**SUBJECT:** COMANCHE PEAK NUCLEAR POWER PLANT, UNITS 3 AND 4  
DOCKET NUMBERS 52-034 AND 52-035  
RESPONSES TO REQUESTS FOR ADDITIONAL INFORMATION  
NO. 2864, 3295, AND 3327

Luminant Generation Company LLC (Luminant) herein submits responses to Requests for Additional Information No. 2864, 3295, and 3327 for the Combined License Application (COLA) for Comanche Peak Nuclear Power Plant Units 3 and 4. The affected COLA pages are included with the responses.

**Response to Request for Additional Information No. 2864 (CP RAI #32)**

**Figure II-1 Emergency Response Organization Interrelationships  
(Alert, Site Area Emergency, General Emergency)**

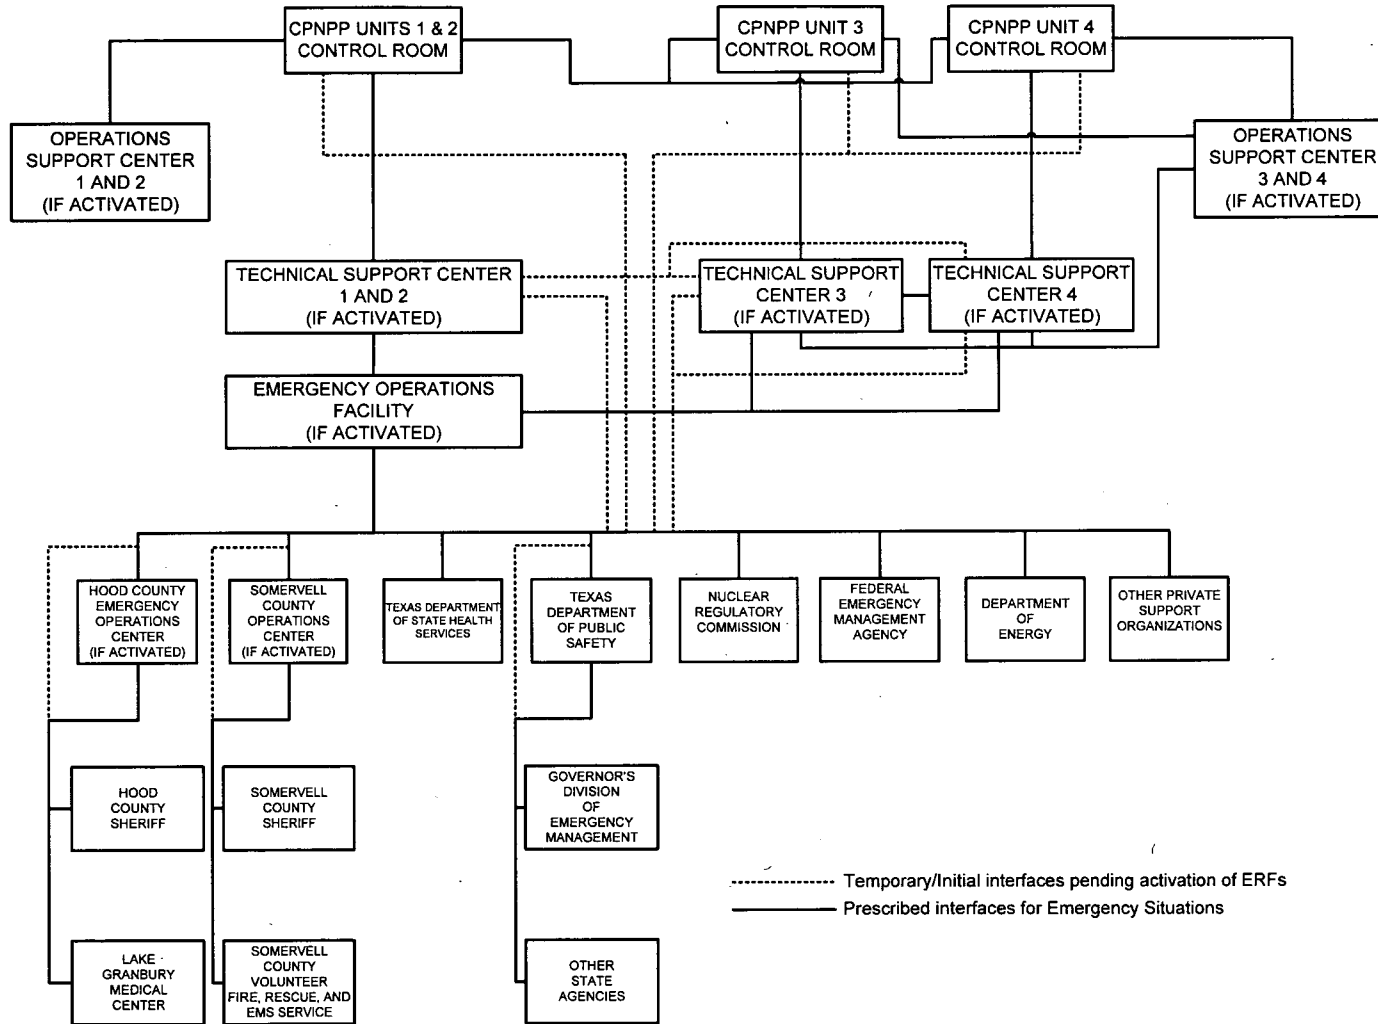
- A-1. The Texas Department of State Health Services is identified as a participating organization, but Figure II-1, "Emergency Response Organization Interrelationships," shows Texas Department of Health. The Radiation Control Program (RCP) of the Texas Department of State Health Services is identified as a participating organization, but is not shown in Figure II-1. Appendix 7, "Certification Letters and Letters of Agreement," includes letters of agreement for five organizations that are not shown in the block diagram.

- A. Clarify whether the block labeled Texas Department of Health in Figure II-1 is the same as Texas Department of State Health Services (TDSHS) in Section II.A.1.a. Revise Figure II-1 as appropriate.

- B. Discuss whether the Radiation Control Program should be shown in Figure II-1. Revise Figure II-1 as appropriate.
  - C. Discuss whether the Environmental Protection Agency (EPA) shown in Section II.A.1.b is a participating organization, and whether it should be listed in Section II.A.1.a and in Figure II-1. Revise Figure II-1 as appropriate.

- D. Discuss whether Walls Regional Hospital, Granbury/Hood County EMS, Granbury Volunteer Fire Department, Tolar Volunteer Fire Department, Indian Harbor Volunteer Fire Department, or DeCordova Bend Estates Volunteer Fire Department, which are listed in Sec.II.A.1.b, should be added to Figure II-1. Revise Figure II-1 as appropriate.

- E. Discuss whether the Cities of Stephenville, Cleburne, and Granbury, the National Weather Service, and the American Red Cross should be shown in Figure II-1. Revise Figure II-1 as appropriate.

- A-1.A Figure II-1 incorrectly referred to the Texas Department of Health. The Texas Department of State Health Services is the successor agency to the former Texas Department of Health. Figure II-1 has been revised to reflect the correct name of the State Agency (see attached marked-up pages).

- A-1.B Figure II-1 identifies the interfaces between the various Federal, State, local and private agencies in the Emergency Response Organization. The Radiological Control Program (RCP) is a part of the Texas Department of State Health Services, which has been identified in the revised Figure II-1 as discussed in the response to A-1.A, above. Therefore, no change to Figure II-1 is necessary to specifically address the RCP.

- A-1.C The Environmental Protection Agency (EPA) may provide assistance in supporting environmental monitoring teams and mobile radioanalytical laboratories, as noted in Section II.A.1.b of the Emergency Plan. However, under the National Response Framework's Nuclear/Radiological Incident Annex, the EPA is a designated cooperating agency providing assistance and support to the NRC (RIS 2005-13). As the Coordinating Agency, the NRC performs the Federal-level functions and coordinates the overall Federal response. Therefore, no change to Figure II-1 is necessary to address the EPA.

- A-1.D Figure II-1 of the Units 3 and 4 Emergency Plan was developed to be consistent with Figure 1.1 of the Units 1 and 2 Emergency Plan. The figure illustrates those organizations with primary responsibility for responding to an emergency at the CPNPP site. As described in Section II.B.6 of the Emergency Plan, Figure II-1 illustrates the interfaces among the Luminant Emergency Response Facilities (ERFs) for Units 3 and 4, Luminant Corporate Support, the State of Texas, and Somervell and Hood County government emergency response organizations.

- A-1.E Stephenville and Cleburne are both located well outside the 10-mile plume exposure pathway Emergency Planning Zone (EPZ) and serve as relocation center locations. Plans and procedures for establishing and operating relocation centers by the cities of Stephenville and Cleburne were included as Supplemental Information in Part 5 of the COLA. Communication with relocation centers in those cities is conducted in accordance with Tab C to Appendix 2 and Attachment E of Annex W of the Hood and Somervell Counties' Emergency Management Plan. No change to Figure II-1 is necessary to address the cities of Stephenville and Cleburne.

**Figure II-2**

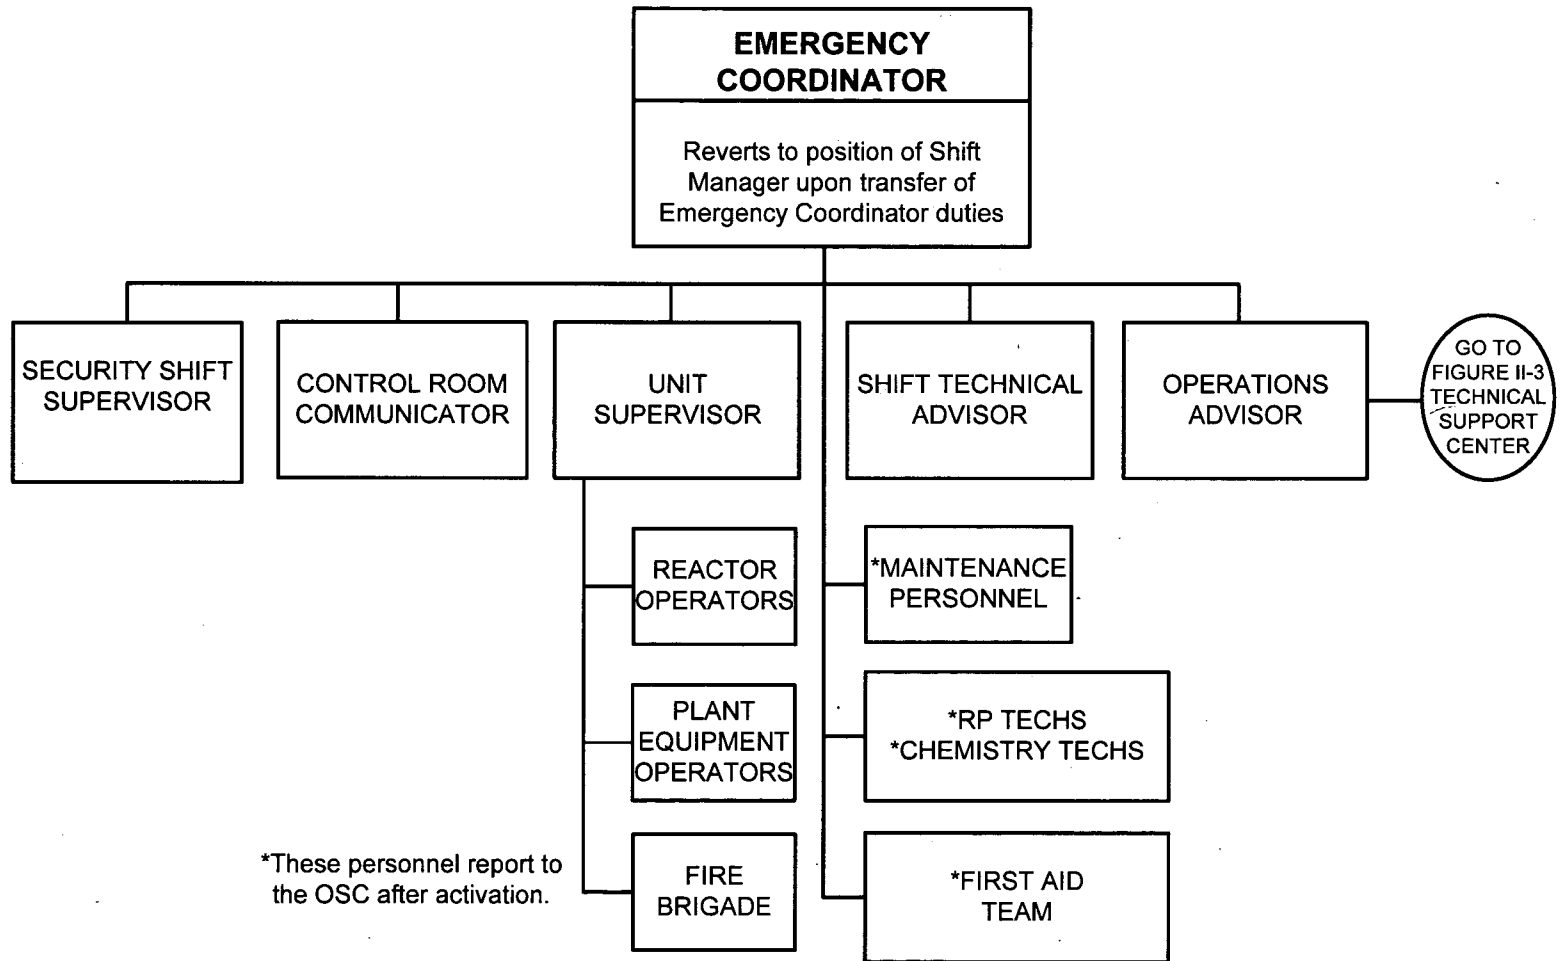
- A. The Security Shift Supervisor described in Section II.B.1 is not shown in Figure II-2. Discuss why the security function is not included in Figure II-2, and revise Figure II-2 as appropriate.

- B. The Emergency Repair & Damage Control Emergency Team described in Section II.B.1 is not shown in Figure II-2. Describe whether the function of emergency repair and damage

control is represented by Maintenance Personnel in Figure II-2. Revise Figure II-2 as appropriate.

B-3.A. Section II.B.1 of the Emergency Plan describes the principal responsibilities that are assigned to the Operations Shift until relieved by members of the ERO. The Security Shift Supervisor has been added to Figure II-2. In addition, Section II.B.1 has been revised by re-ordering the first two paragraphs, which should clarify that Figure II-2 is for the initial phase of an emergency.

B-3.B Section II.B.1 of the Emergency Plan describes the principal responsibilities that are assigned to the Operations Shift until relieved by members of the ERO. The Maintenance Personnel shown in Figure II-2 perform the Emergency Repair and Damage Control function initially, until such time as the Operations Support Center (OSC) is manned. Section II.B.5 includes a description of the Emergency Repair & Damage Control Emergency Team Coordinator as follows:

There is no need to revise Figure II-2. However, as discussed in response to part B-3.A above, Section II.B.1 has been revised to improve clarity.

Figure II-4 Emergency Response Organization – Operations Support Center

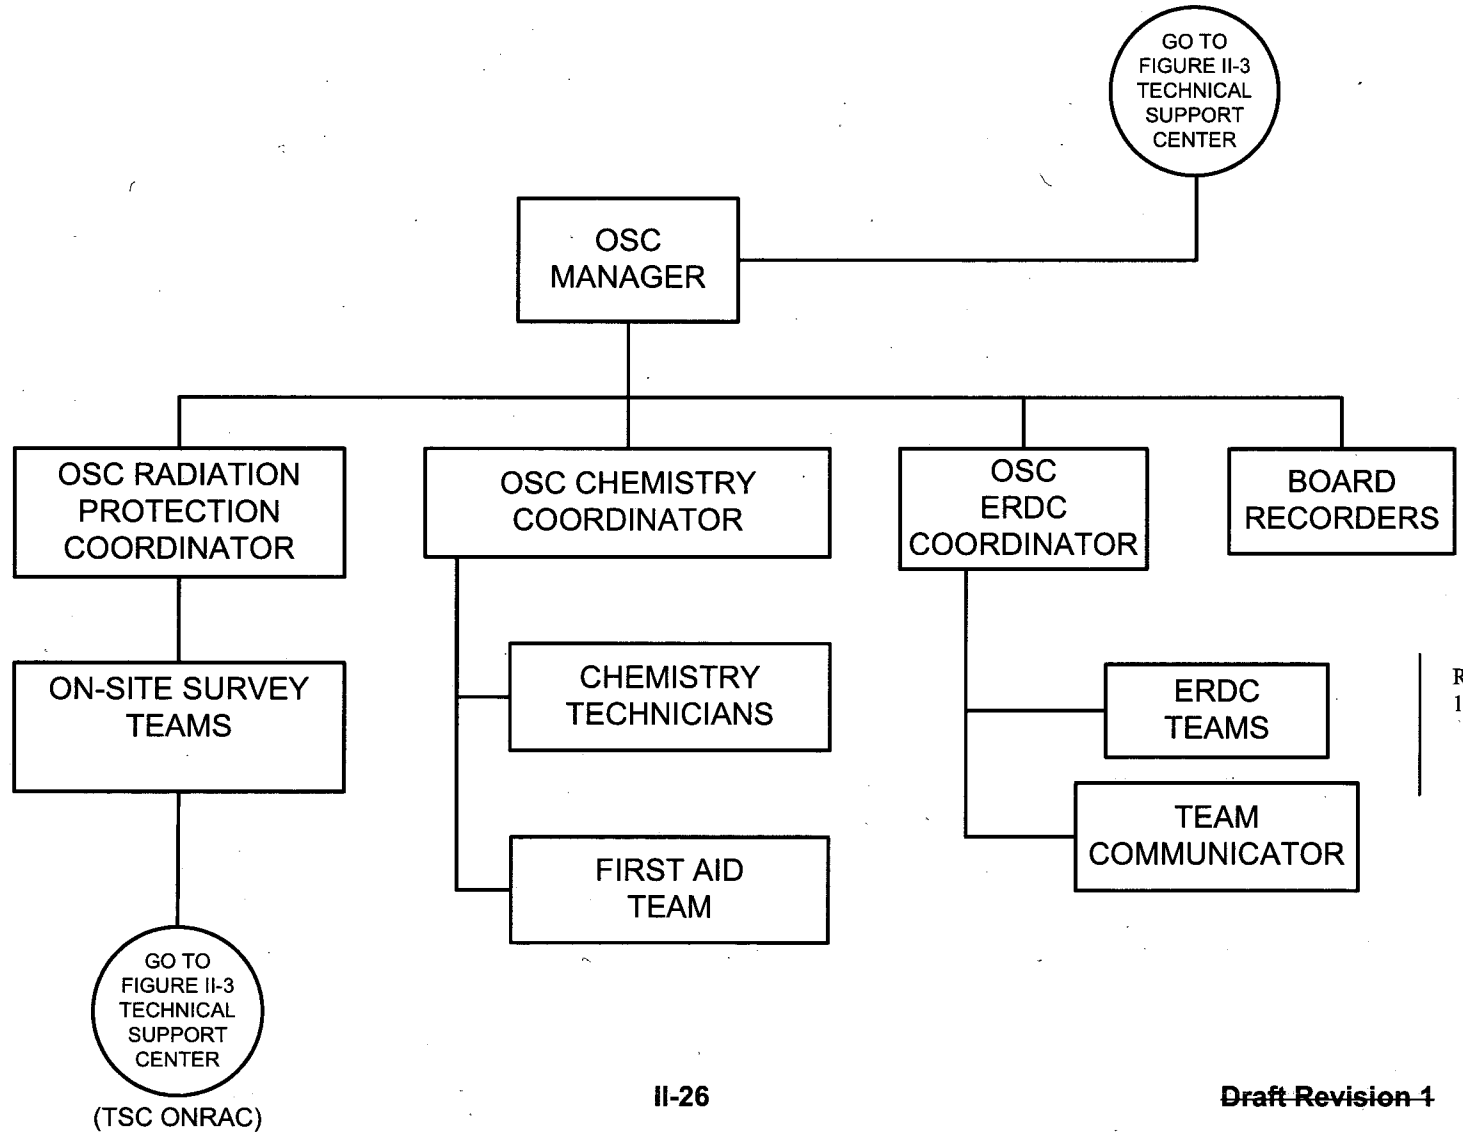
- E. Section II.B.5, "Plant Emergency Response Positions," includes a description of On-Site Survey Teams dispatched from the OSC; however, Figure II-4, "Emergency Response Organization – Operations Support Center," does not include an entry for On-Site Survey Teams. Clarify if the Radiation Protection Technicians shown in Figure II-4 are equivalent to the On-Site Survey Teams described in Section II.B.5.

- B-3.E. The Radiation Protection Technicians shown in Figure II-4 are equivalent to the On-Site Survey Teams described in Section II.B.5. It is important to note that the second member of a two person team need not be an RPT. Figure II-4 has been revised to include "On-site Survey Teams."
